PCN Number: 1604-1
Chgnot.doc rev. __ 8/16

Product/Process Change Notification (PCN)

Allegro is discontinuing its legacy UA 3-pin single inline package (SIP) as we invest in our next generation UA SIP featuring advancements in assembly technology, a matrix high density (HD) leadframe, and state of the art mold compound. Please take note of the minor dimensional and material changes.

Legacy UA

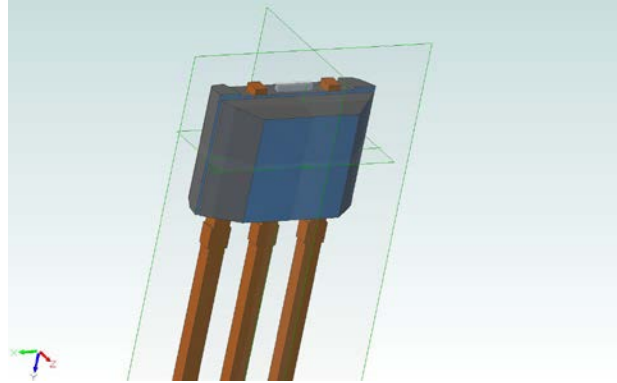
Legacy UA vs Matrix HD UA - Visual Differences

Matrix HD UA

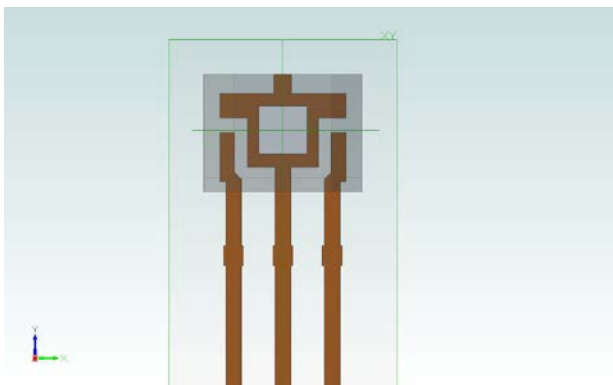
- Top of package on the Matrix HD UA has tie and dam bar protrusions

Legacy UA leadframe

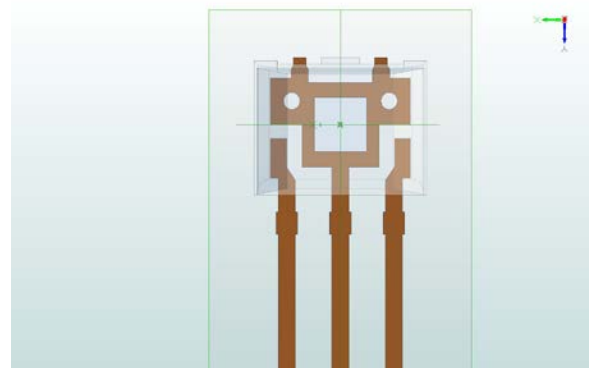
Legacy UA vs Matrix HD UA – Leadframe Differences

Legacy UA

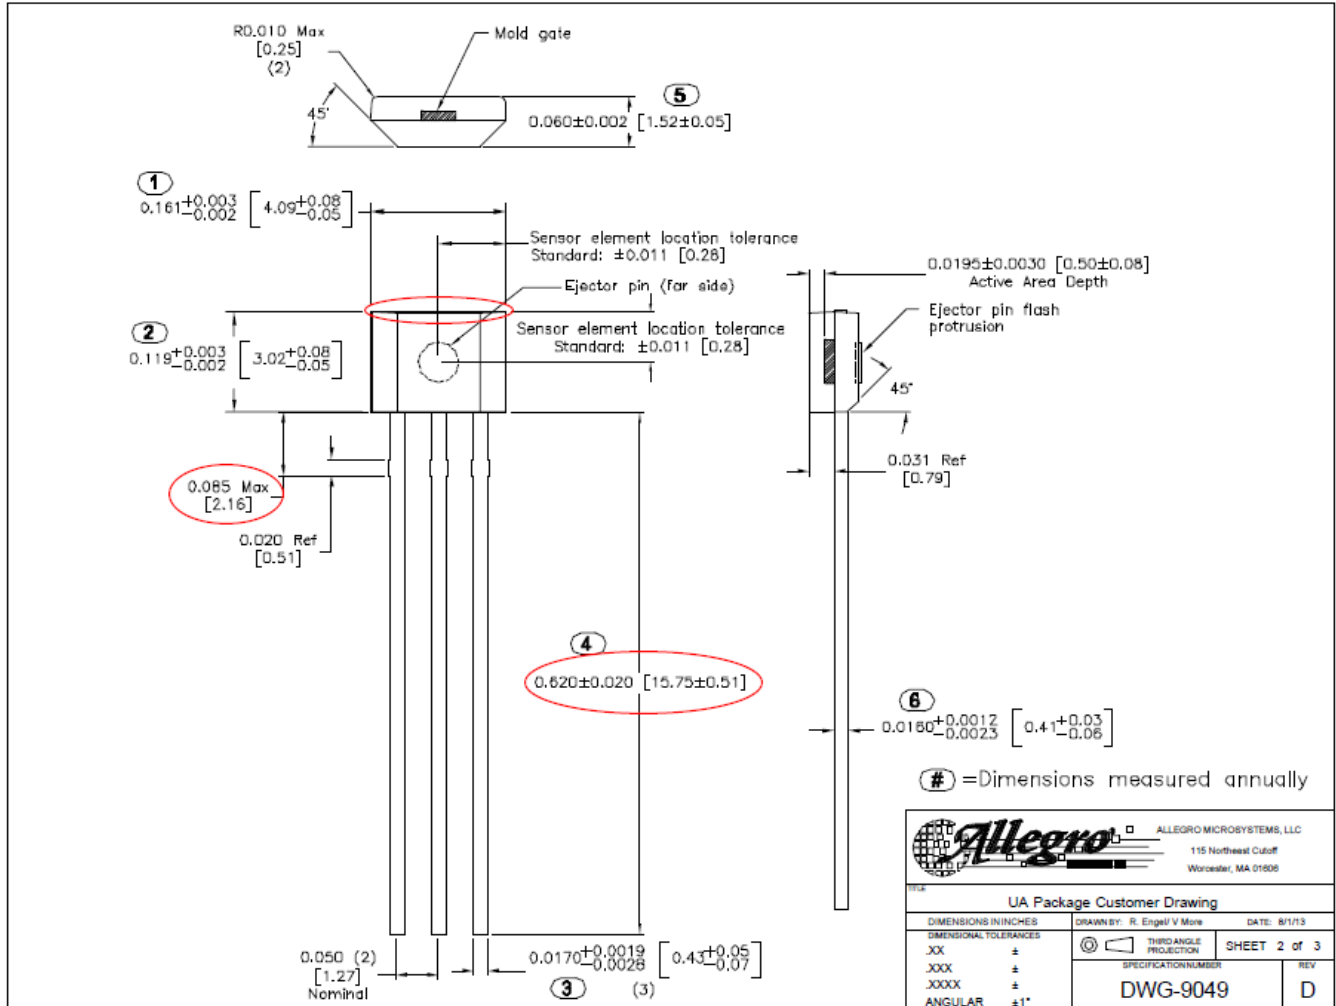
Legacy UA vs Matrix HD UA – Dimensional Comparison

Package	Width (mm)	Height (including tie & gate bar protrusions) (mm)	Lead Length (mm)	Leadframe Mold Offset (mm)
Legacy UA	4.09 (+0.08, -0.05)	3.02 (+0.08, -0.05)	15.75 +/-0.51	+/-0.101
Matrix HD UA	4.09 (+0.08, -0.05)	3.02 (+0.08, -0.05)	14.99 +/-0.25	+/-0.051

Matrix HD UA

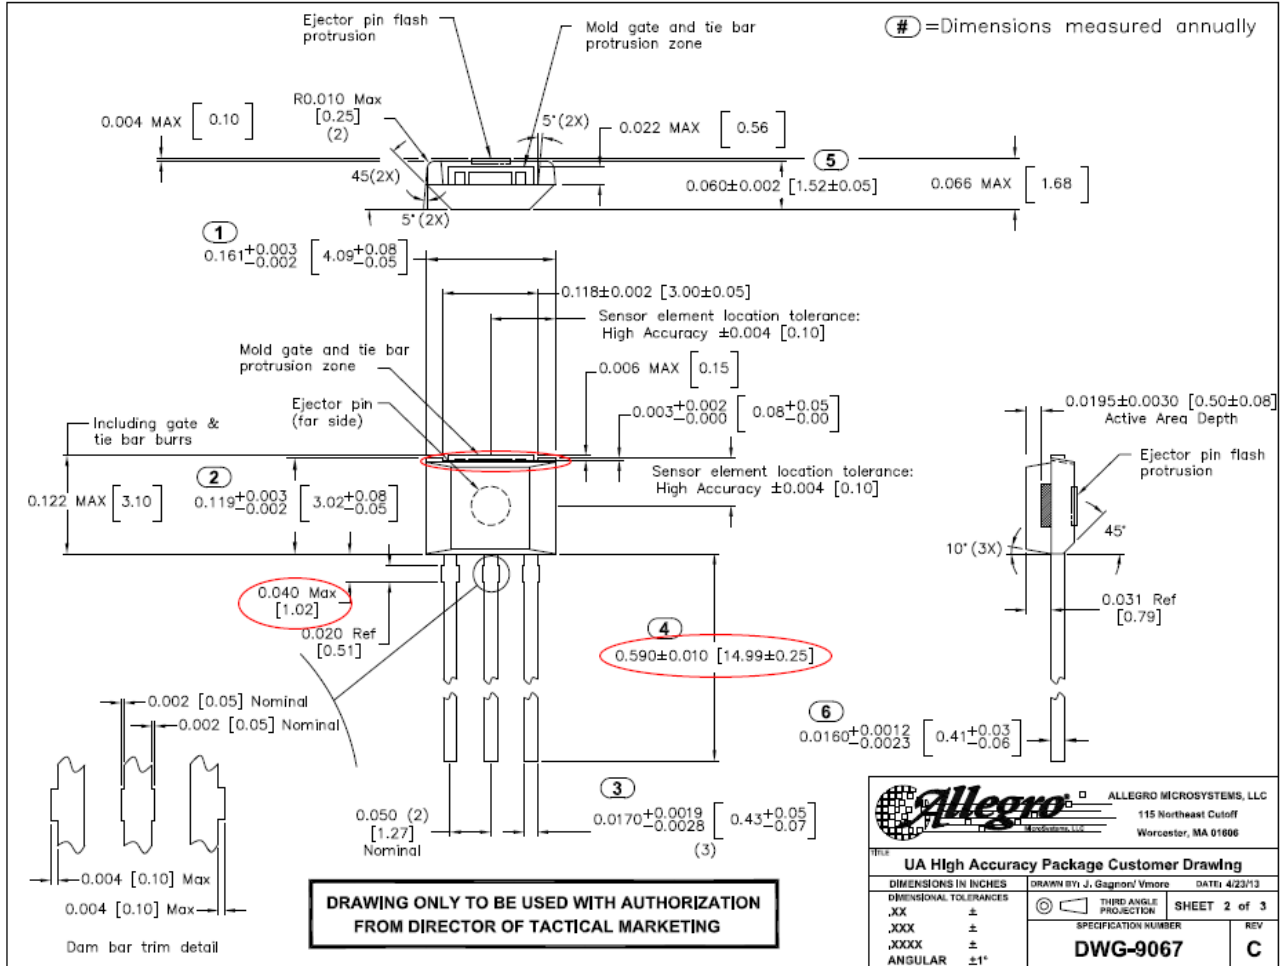
Legacy UA vs Matrix HD UA – Dimensional Comparison Continued
